CLAREMONT BUSINESS PARK 2 FILING NO. 1

STREET IMPROVEMENT PLANS

AUGUST 2020

EL PASO COUNTY FILE NO. PCD # SF-20-014

TYPICAL CURB AND GUTTER DETAIL (SD 2-20C)

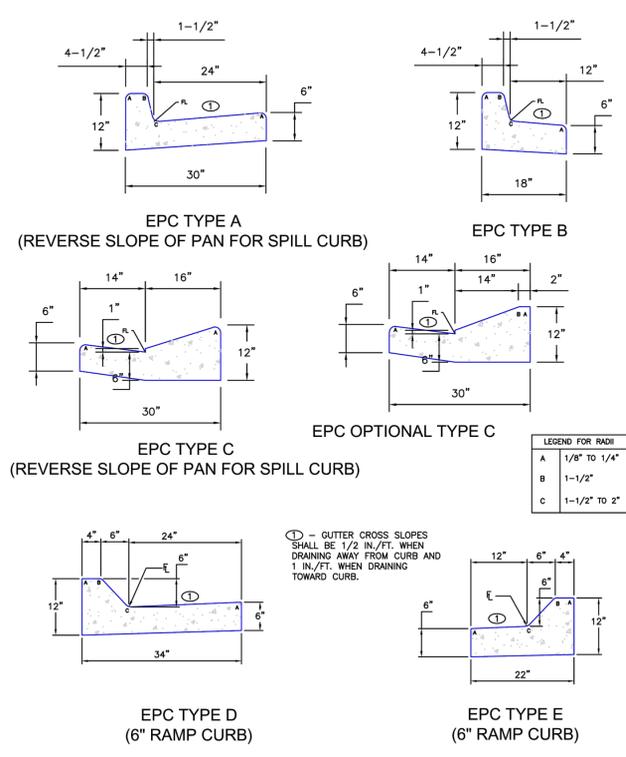
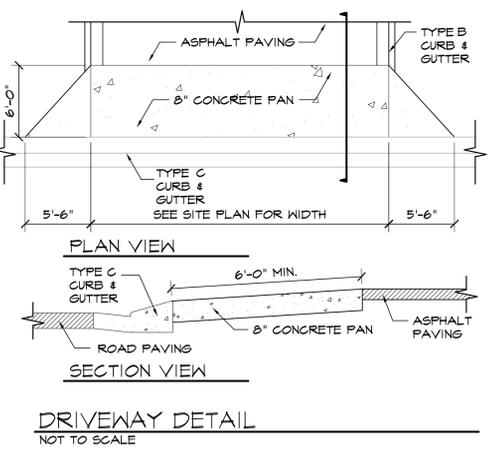
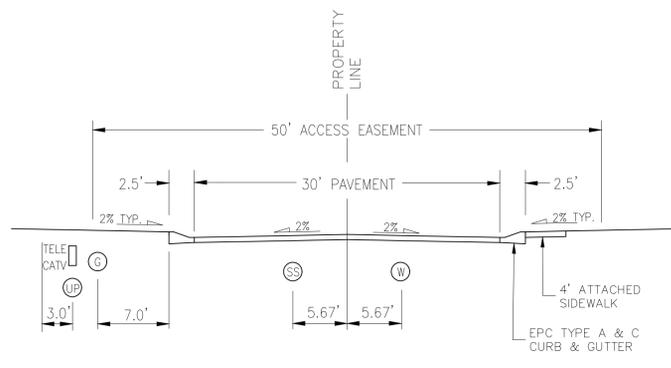
Please use the latest detail that was approved by the BoCC with the addition of Chapter 6 to the ECM. I have attached a PDF of Ch6 which includes this detail.

GARY WATSON PT (PRIVATE)

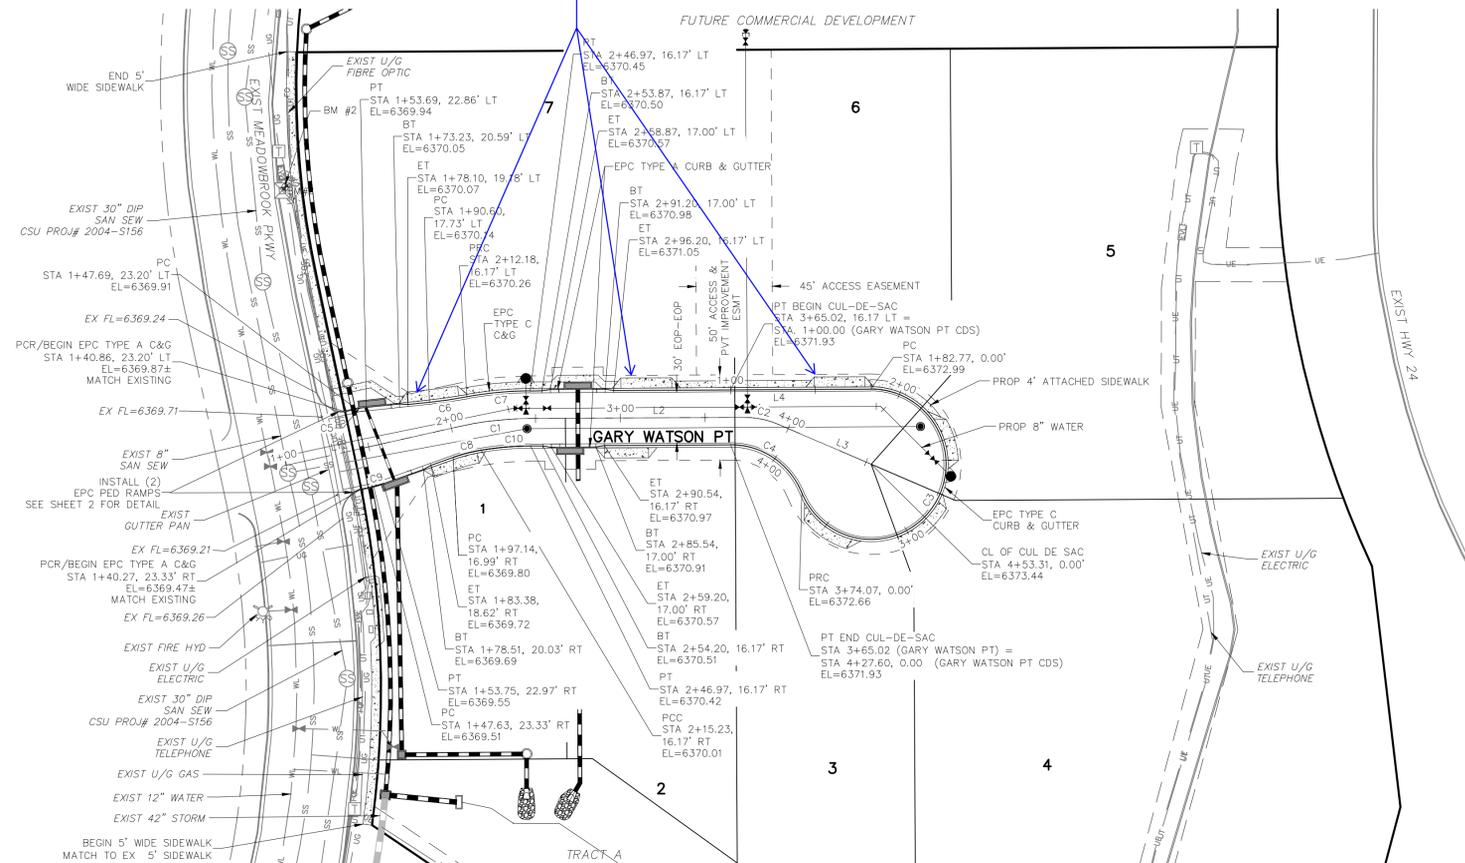
Revise the sidewalk to go around the driveway. The sidewalk as currently shown would not meet ADA standards. Refer to county standard detail SD_2-24

Sidewalk has been revised to match that of the SD_2-24

STORM 7
 STA 1+00.00 TO STA 3+45.30
 (PRIVATE)

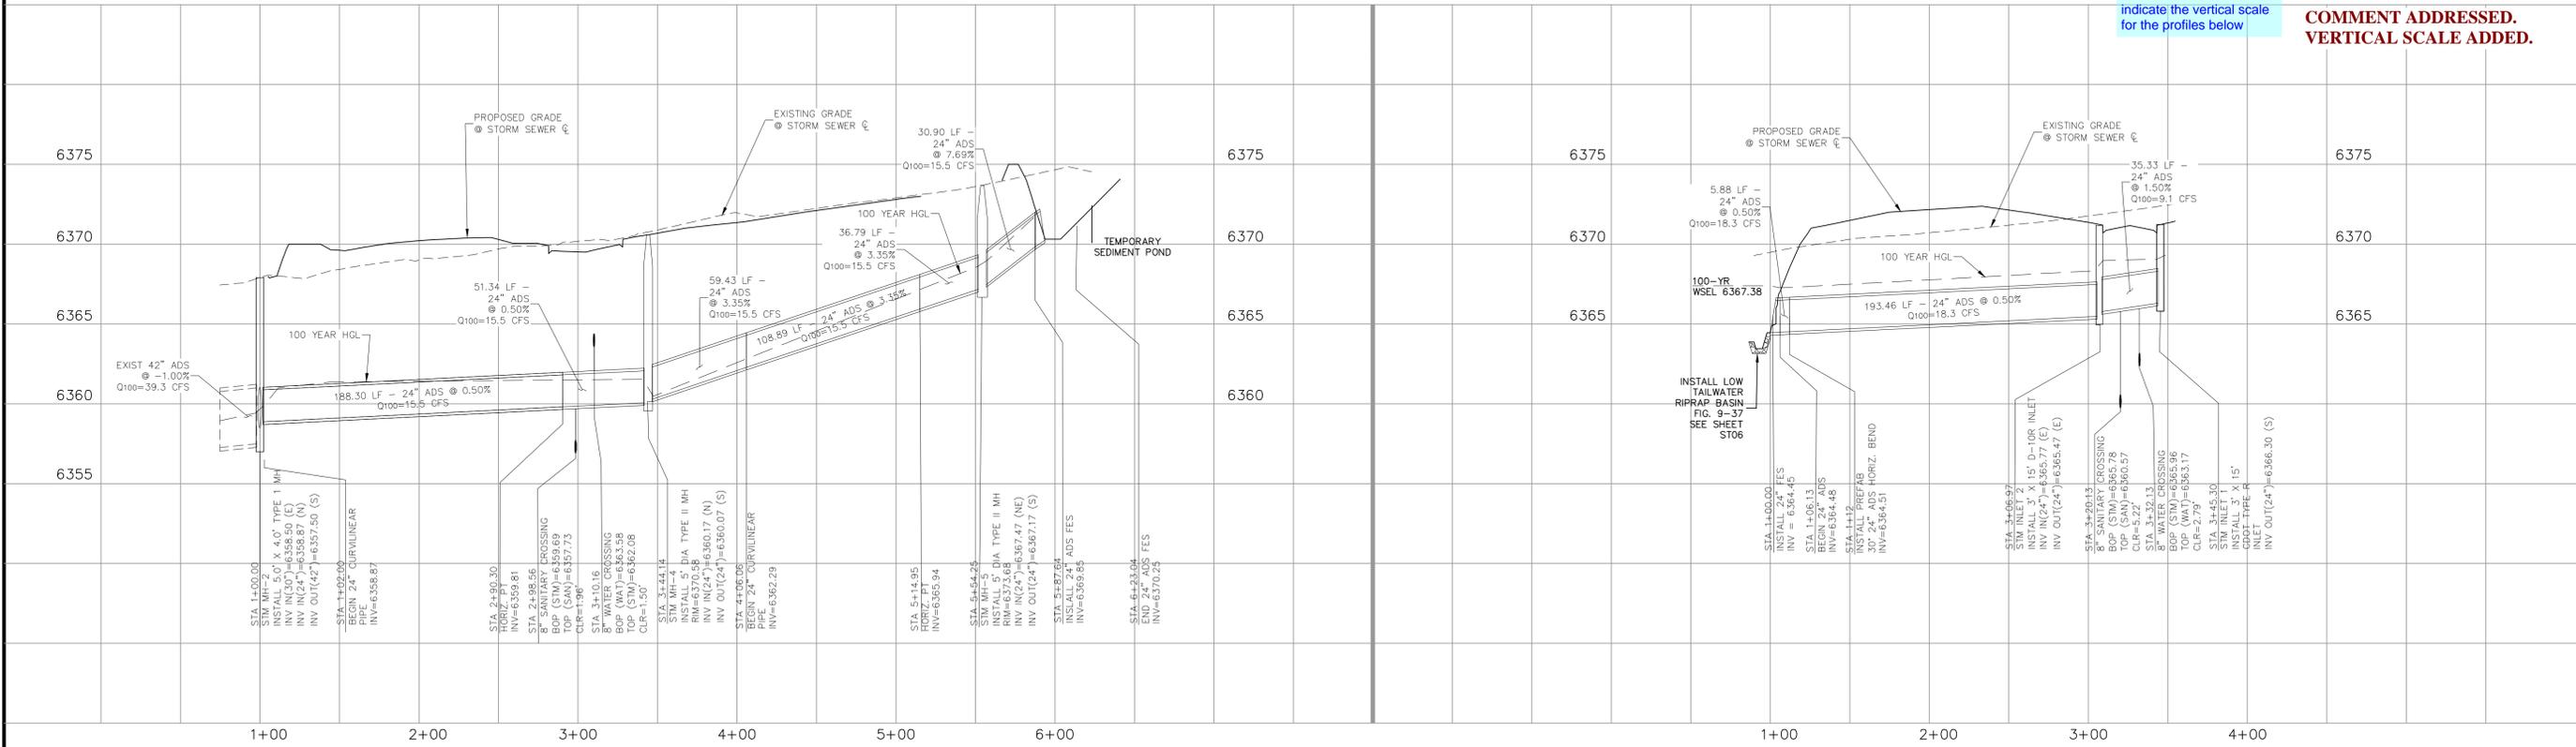
Review 1: Identify the vertical scale
 Review 2: Unresolved.
 indicate the vertical scale for the profiles below

COMMENT ADDRESSED.
 VERTICAL SCALE ADDED.

STORM 11
 STA 1+00.00 TO STA 1+43.87
 (PRIVATE)

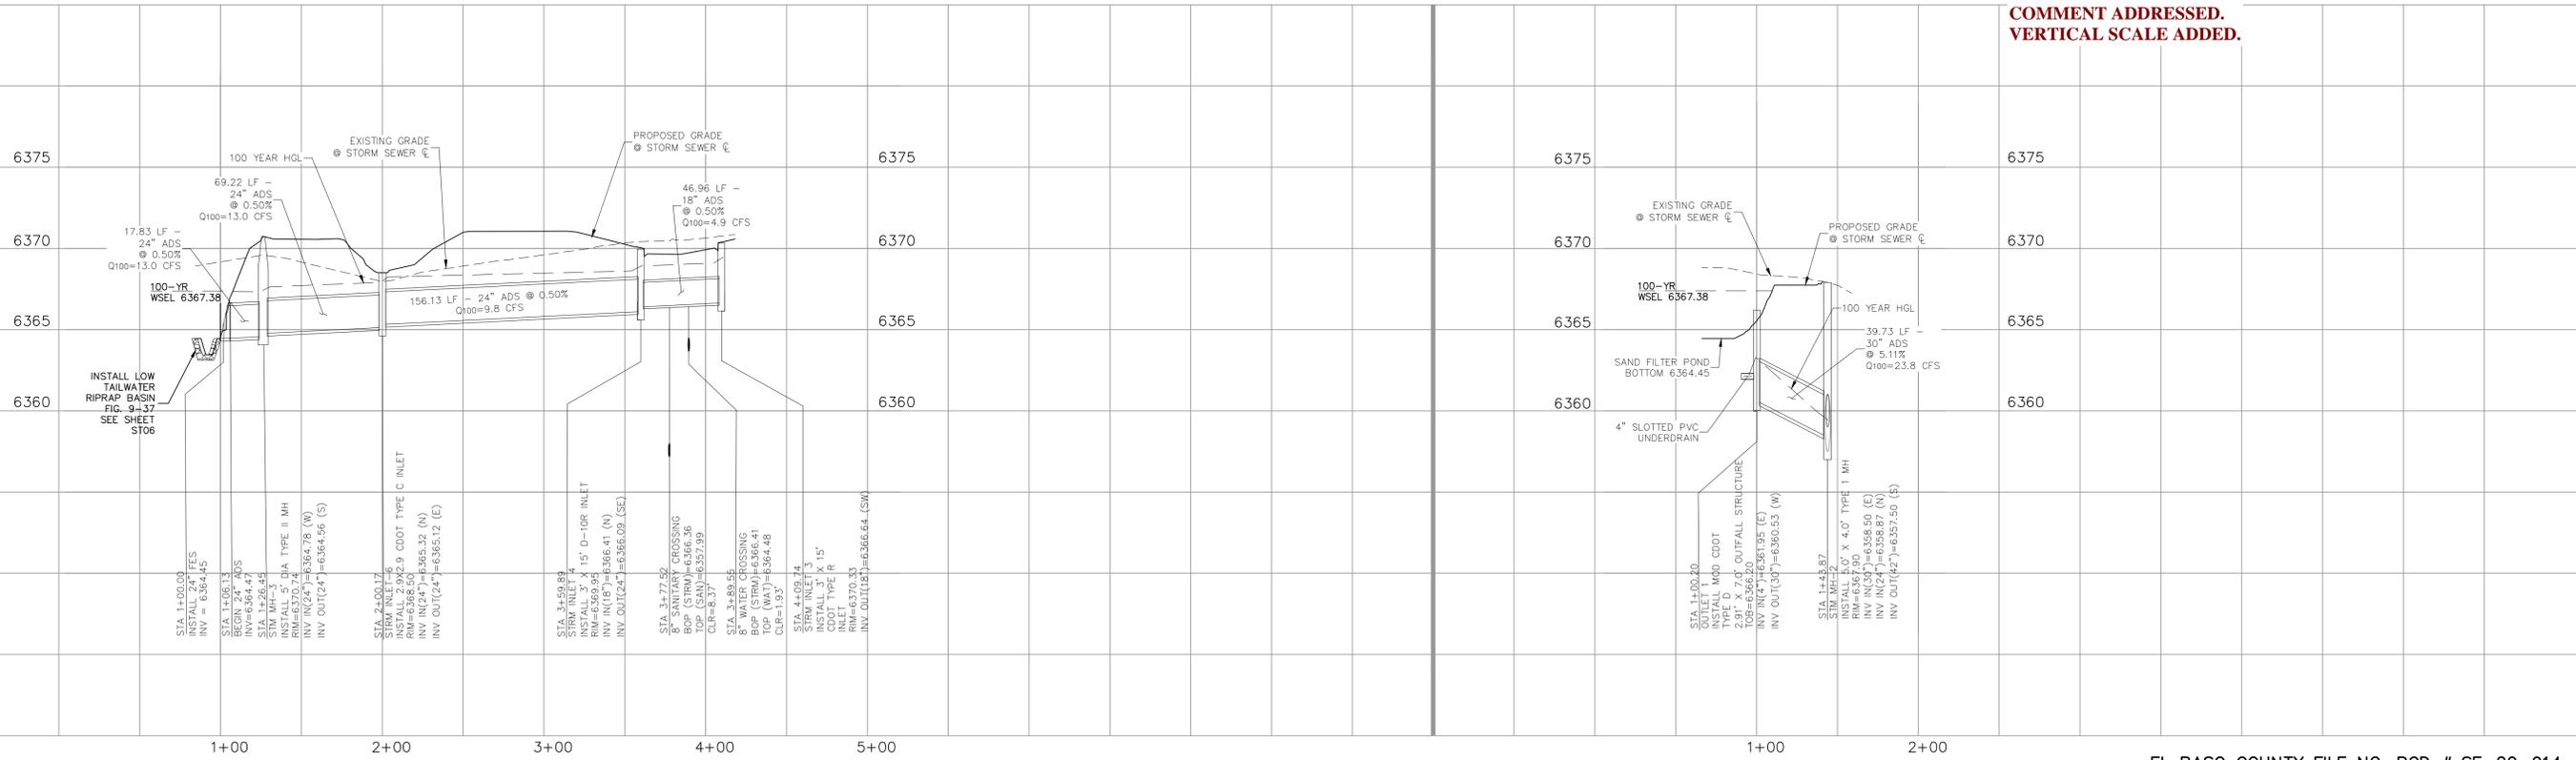
Review 1: Identify the vertical scale
 Review 2: Unresolved, indicate the vertical scale for the profiles below

COMMENT ADDRESSED.
 VERTICAL SCALE ADDED.

SPILLWAY SECTION A-A (PRIVATE)
 NOT TO SCALE

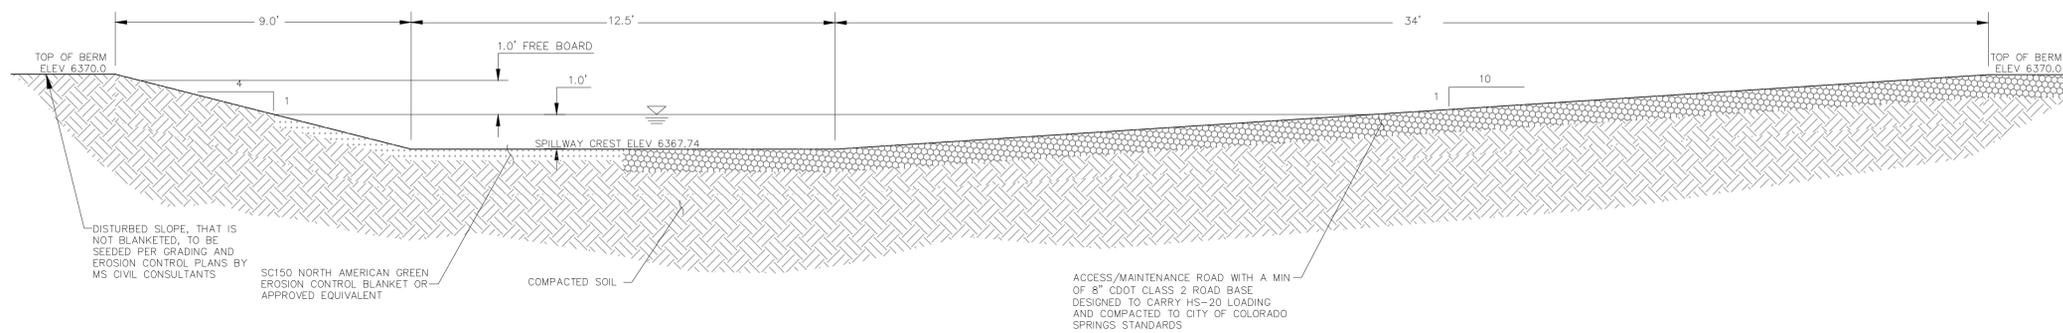
Please provide a cross section detail of the swale that is conveying the flow (DP8) to the riprap rundown

**COMMENT ADDRESSED.
 SEE DETAIL ABOVE FOR CROSS-SECTION. SEE ST01 FOR OPEN CHANNEL CALCULATOR SHEET.**

SAND FILTER WATER QUALITY POND 2 (PRIVATE)

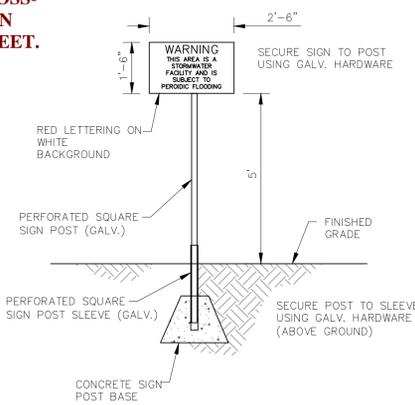
Label location of underdrain cleanout and label cleanout as straight PVC (not slotted)

**COMMENT ADDRESSED.
 NOTE ADDED CLEANOUT AT END AND AT CHANGE OF HORZ DIRECTION.**
